SUBJECT: 410 5th Avenue
Views on 5th Request for Deviation from Standard – 4th Avenue
Elimination of the 8 ft Parking Lane

SUBJECT: 410 5th Avenue
Views on 5th Request for Deviation from Standard – 5th Avenue
Elimination of the 8 ft Parking Lane

SUBJECT: 410 5th Avenue
Views on 5th Request for Deviation from Standard – Simmons Street
Elimination of the Parking Lanes and Install a Left Turn Lane for Northbound Traffic

SUBJECT: 410 5th Avenue
Views on 5th Request for Deviation from Standard – Sylvester Street
Elimination of the 5 ft wide Bike Lane

4TH AVENUE PROPOSED SECTION
FIGURE 1

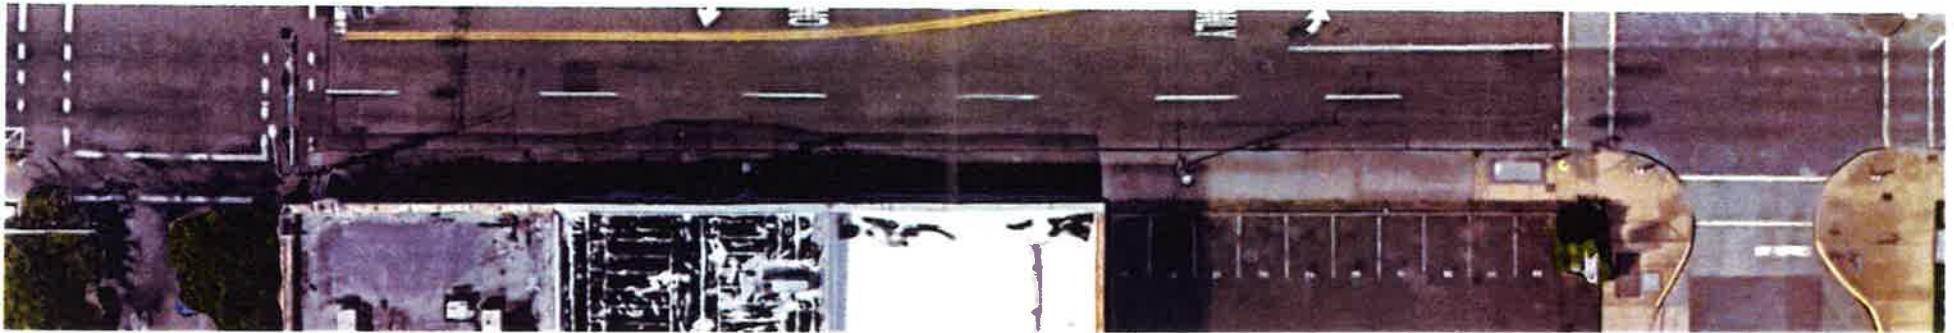
The Commercial Collector Street Standard in the EDDS calls for an 8-foot wide parking strip with a 10-foot wide, concrete sidewalk, and four travel lanes. The required right of way is 83-feet. (Although ordinarily required in the collector street standard, 4th Avenue from Simmons Street easterly is specifically exempt from providing 5-foot bike lanes per EDDS 4D.020.) Specifics of the proposed street section are shown on the attached Figure 1.

- All other improvements proposed for 4th Avenue shall comply with the EDDS, unless otherwise approved by the City.
- The street trees shall be offset from the building alcoves to maximize the sidewalk area available to pedestrians.
- Obstructions into the 4th Avenue sidewalk are not allowed, i.e. door swing and bicycle parking, in order to maximize sidewalk width available for pedestrian traffic.
- Ensure that storm drainage adjacent to the curb is adequate to eliminate the potential for ponding, for a better pedestrian experience.
- The proposed bollards shall be illuminated.

EXHIBIT B - 4TH AVENUE
PARTIAL SITE PLAN

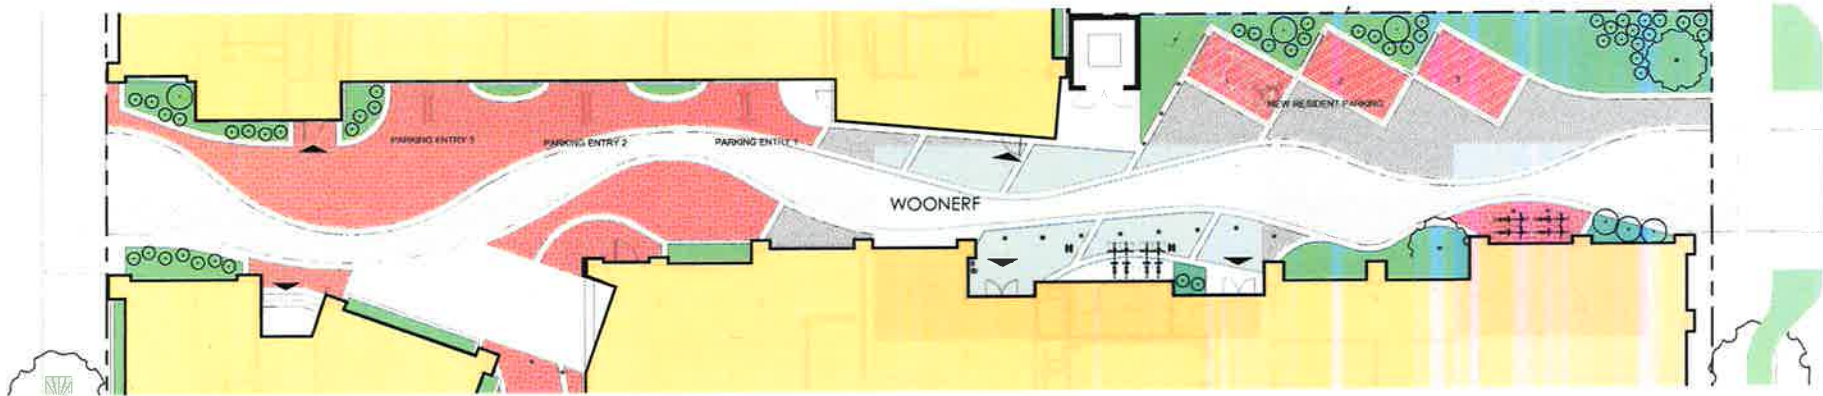
Additionally, the Views on 5th project proposes pedestrian amenities that create a far superior quality of pedestrian experience in the following ways along 4th Avenue (See also Exhibit B):

- **Providing building undulation of the ground floor provides additional open space, creating sidewalks varying in width from 10-feet to 13-feet, yielding space for additional seasonal landscaping, benches, and bicycle parking, all in addition to the standard pedestrian sidewalk surface.**
- **Additional space is also provided on 4th Avenue for covered seating at the transit stop adjacent to the building.**
- **The Views on 5th project proposes a mid-block “woonerf” connecting Simmons and Sylvester Streets to relieve some of the pedestrian and vehicular circulation around the perimeter of the site.**

5TH AVENUE PROPOSED SECTION
FIGURE 1

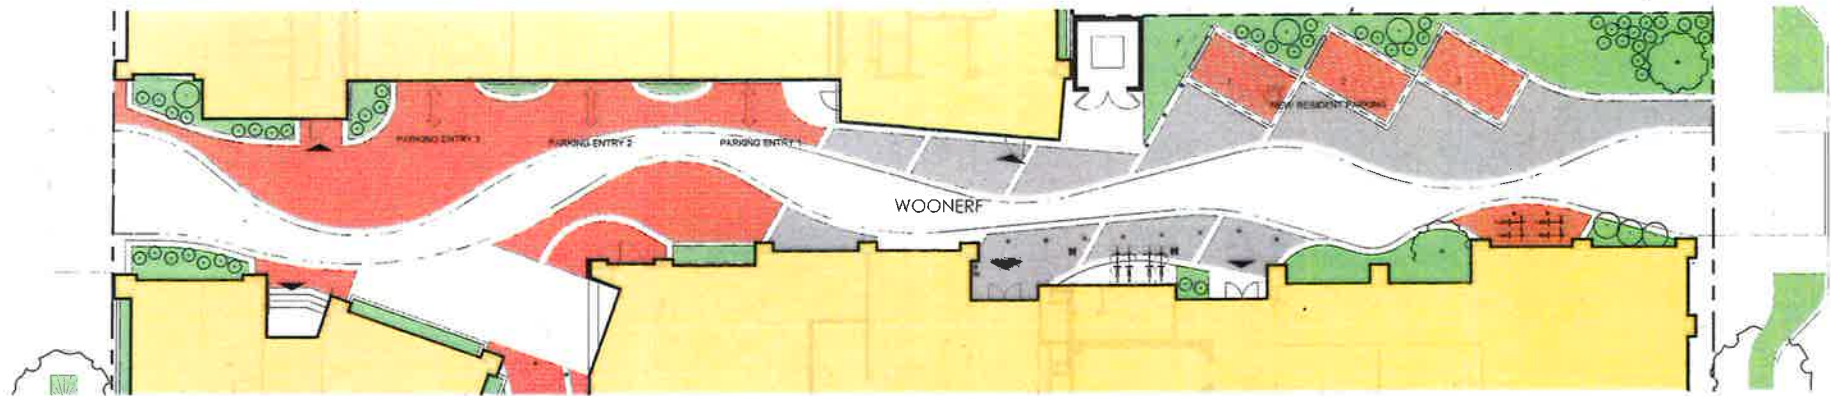
The Commercial Street Standard in the EDDS calls for an 8-foot wide parking strip and a 10-foot concrete sidewalk. With four travel lanes and dedicated bike lanes, total required right of way would be 88-feet. The proposed deviation provides for 4 travel lanes, 2 bike lanes, and sidewalks within 72-feet of right of way. Specifics of the proposed section are shown on the attached Figure 1.

- All other improvements proposed for 5th Avenue shall comply with the EDDS, unless otherwise approved by the City.

SIMMONS STREET PROPOSED SECTION
FIGURE 1

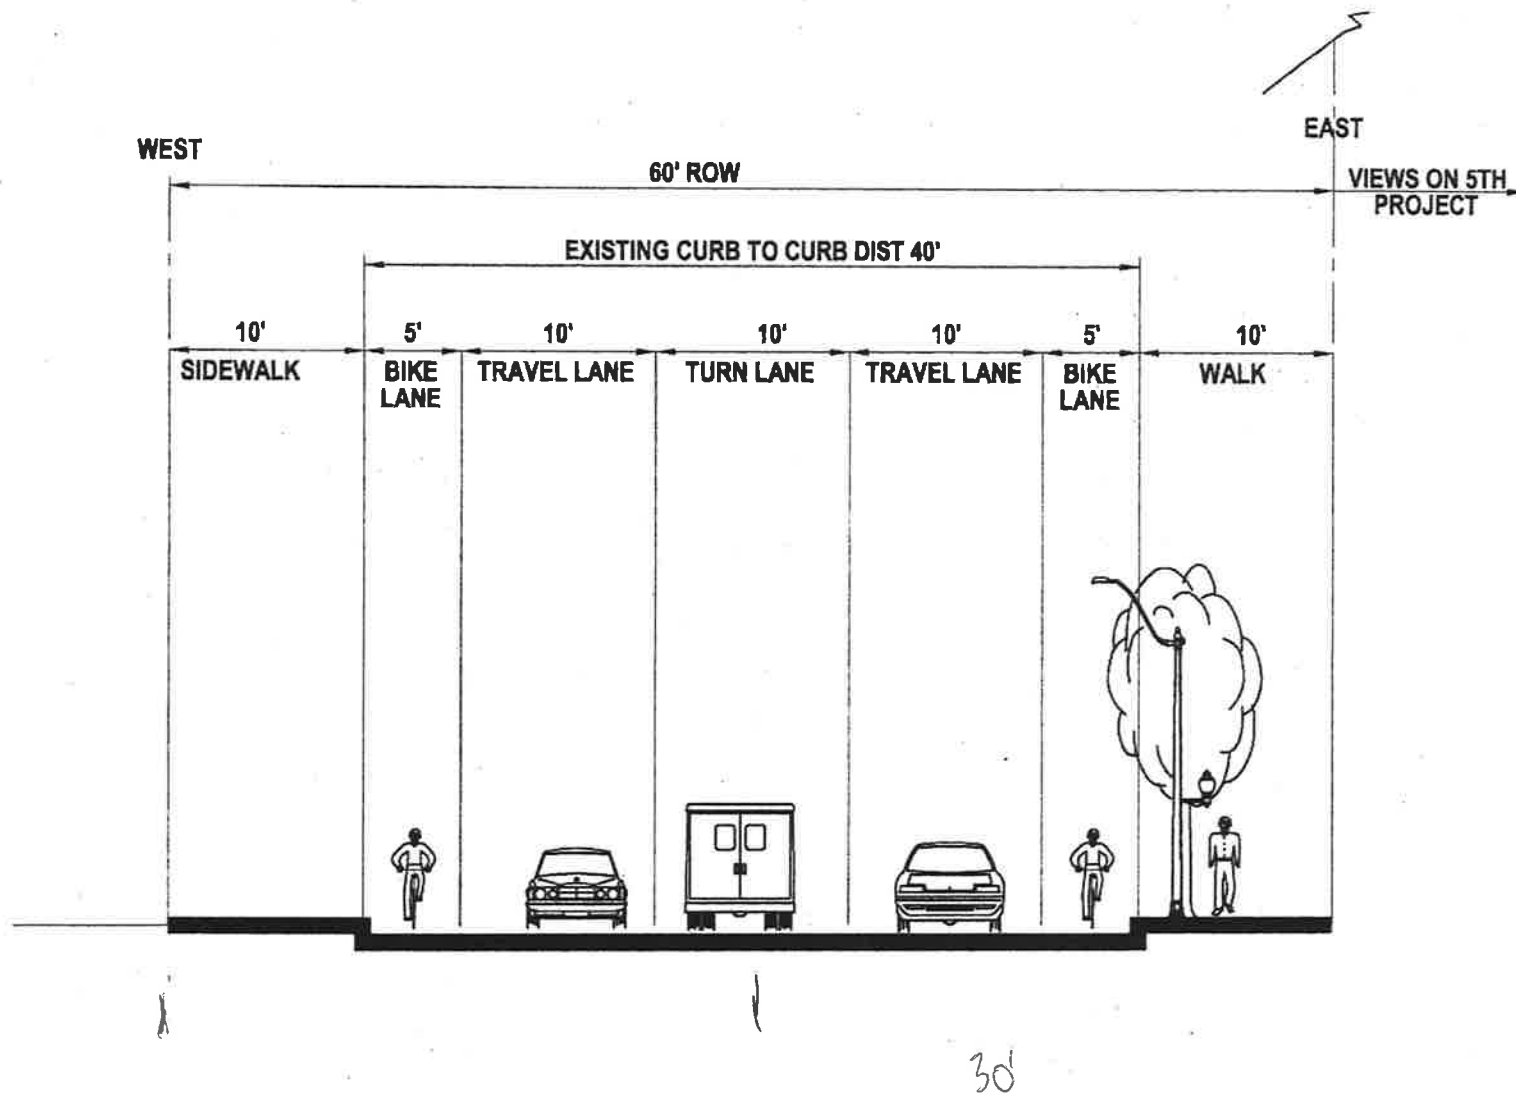
Nevertheless, during project review, City staff expressed a desire for the project to include a northbound left turn lane at this intersection to improve the long-term overall queuing function of both the Simmons/4th and Simmons/5th intersections. See TIA pages 21-22. The applicant is willing to construct this City-requested street improvement, but can only do so if the proposed deviation is also granted to eliminate the required parking on both east and west sides of Simmons Street. See Figure 1 for the proposed street section.

- All other improvements proposed for Simmons Street shall comply with the EDDS, unless otherwise approved by the City.

SYLVESTER STREET PROPOSED SECTION

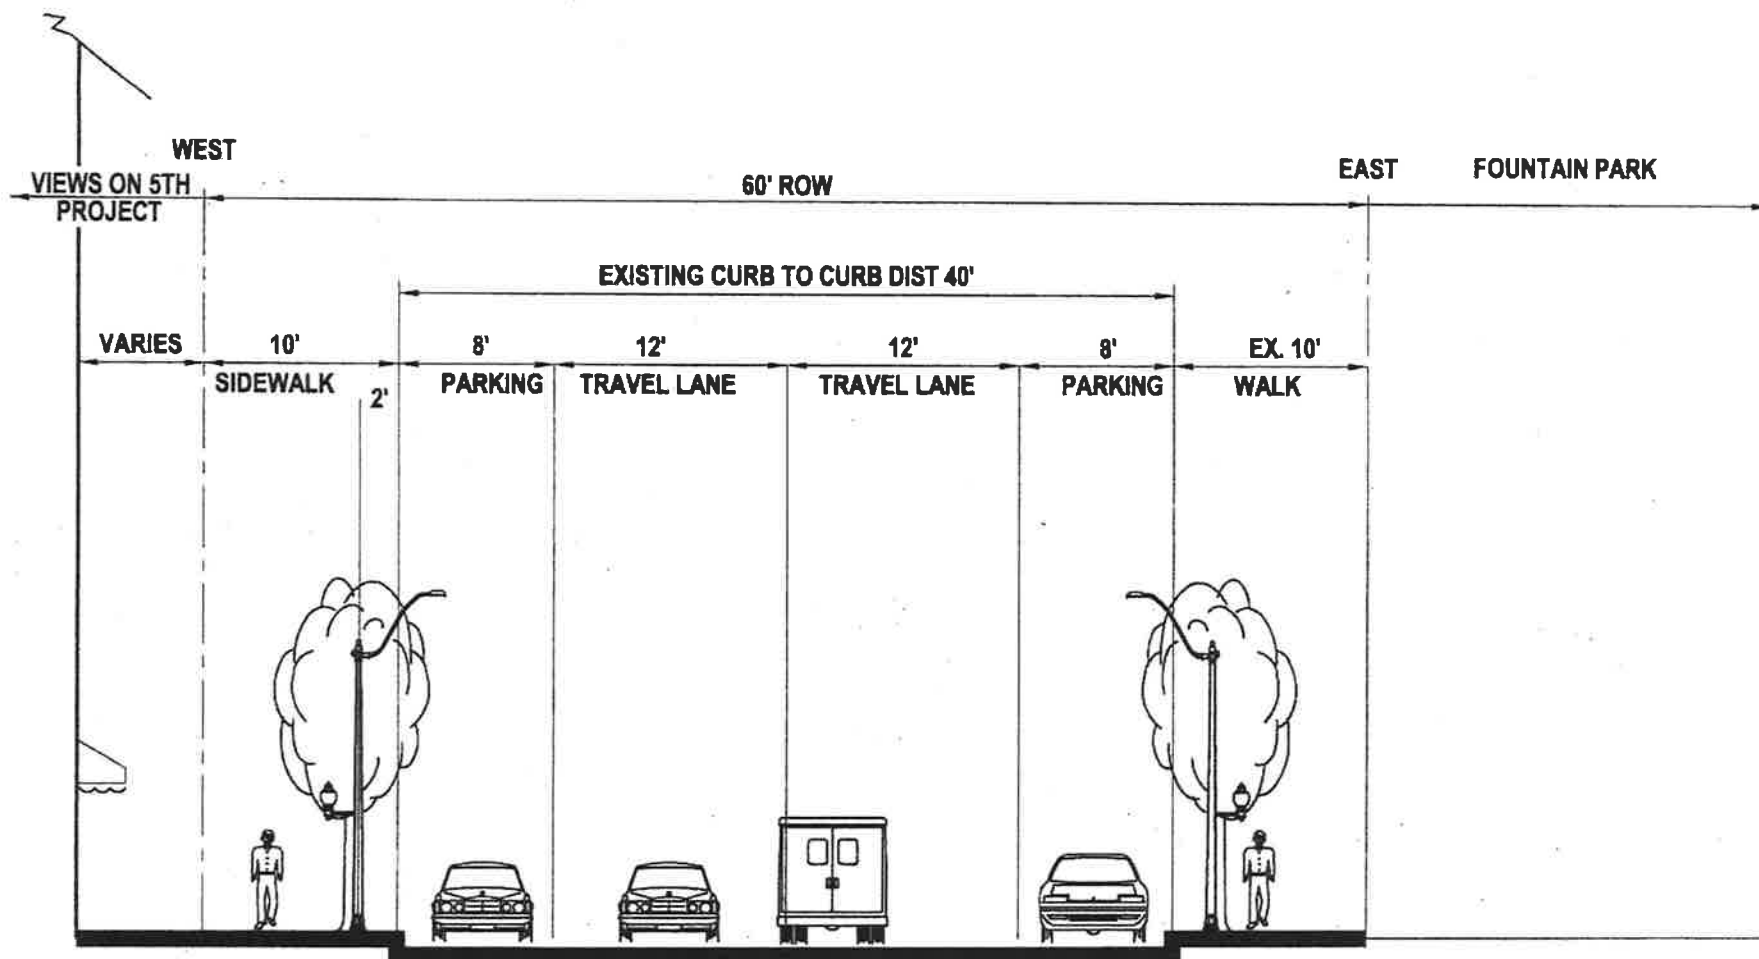
The Commercial Collector Street Standard in the EDDS calls for 5-foot bike lanes in addition to two 12-foot travel lanes, parking on both sides of the street and 10-foot sidewalks. The total required right of way is 68-feet, half-street width of 34-feet. The proposed deviation would eliminate the bike lane across the project frontage. This would reduce the half-street right of way requirement to 29-feet. A full 30-feet of half-street right of way exists. See Figure 1.

This letter is to acknowledge the request for deviation and document that the proposed street cross section for Sylvester Street, between 4th and 5th Avenues accompanying this request does not require approval of a deviation. The proposed street cross section shall be reviewed and permitted via the Engineering Plan Review process.
